Reg No.: 20/0736

Notice to Proponent of Property Development

Proposed Activity: PROPERTY DEVELOPMENT

Location: 90-102 REGENT STREET, REDFERN

TITLE
**CONTROLLED ACTIVITY ASSESSEMENT
LOCATION DIAGRAM
90-102 REGENT STREET, REDFERN**
PROPERTY DEVELOPMENT

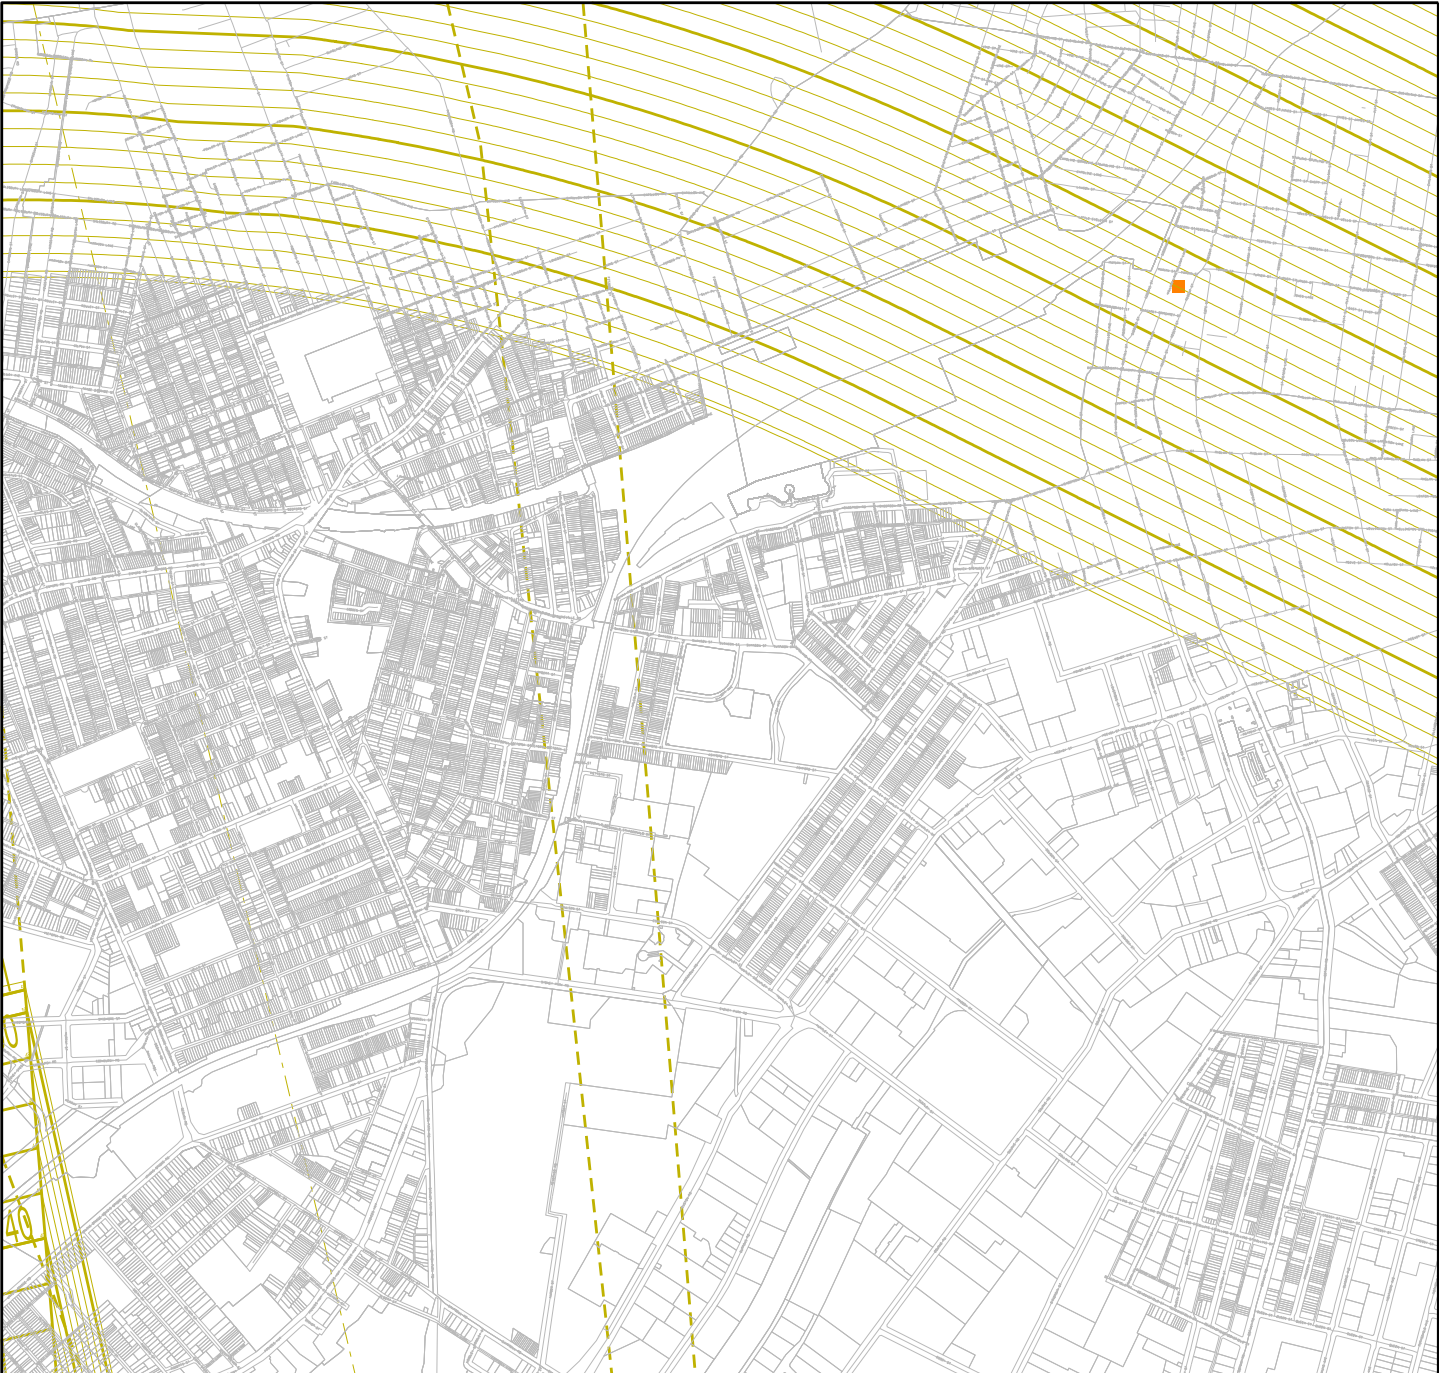
In my capacity as Manager, Airfield Spatial & Technical Planning and an authorised person of the Civil Aviation Safety Authority (CASA) under Instrument Number: CASA 229/11, in this instance, I have no objection to the erection of this development to the following maximum heights as detailed in the attached diagrams:

CORNER	EASTING (MGA94)	NORTHING (MGA94)	HEIGHT (m AHD)
B1	333523.266	6248232.176	86.3
B2	333545.492	6248229.014	86.3
B3	333523.981	6248209.408	86.0
B4	333530.451	6248206.869	86.0
B5	333517.520	6248203.274	84.3
B6	333534.518	6248199.847	84.3

The approved height is inclusive of all lift over-runs, vents, chimneys, aerials, TV antennae, construction cranes etc.
